1 Products affected

Product hierarchy no. *				Part no.	SBU	Type / Description	Customer part no.
SBU	PG	PUG	Type				
02	007	012	0000002391	See list below	Appliance Outlet	5091

2 Type of change

Change of approval and rating markings on the moulding body.

Old product appearance	New product appearance

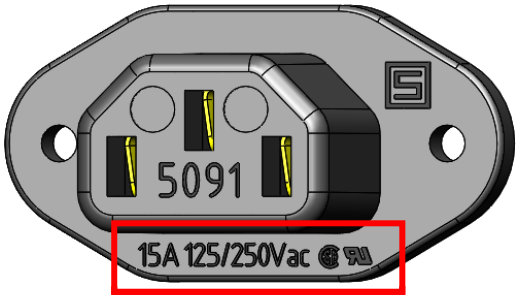
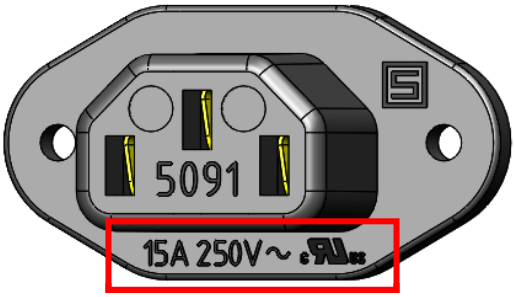
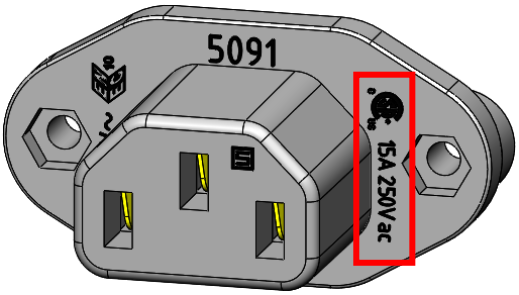
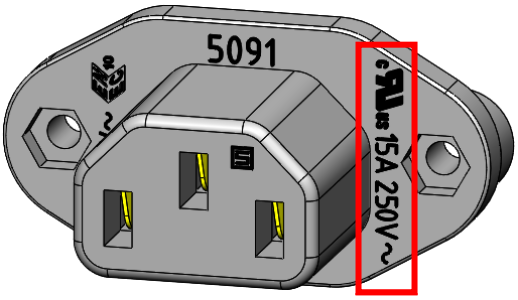
Old product appearance	New product appearance
Flange with through holes special type

Please note that only rivet-on mounting types and special type are ilustrated. However, the same changes apply to both mounting types with screw flange as listed in the affected part numbers list in chapter 1.

Standards update according to the new UL/CSA 60320-1
